## Product Change Notice (PCN)

Ref no: 3009051

**Concerning Part Name:** PISR

**Product Type:** Power Inductor

### Description of Change:

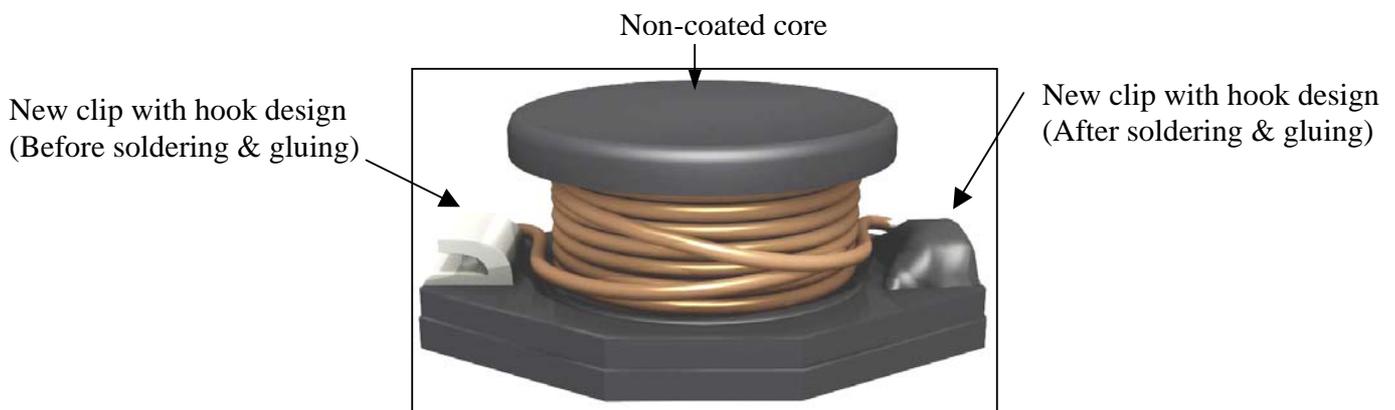
Transition Version --> new clip and base (refer to picture)

REASON for clip: To improve the wire termination robustness and to introduce lead free solder

REASON for base: To match the new clip design

Complete Version --> new ferrite core, non-coated (refer to picture)

REASON: To improve marking permanency and adhesive strength between core and base.
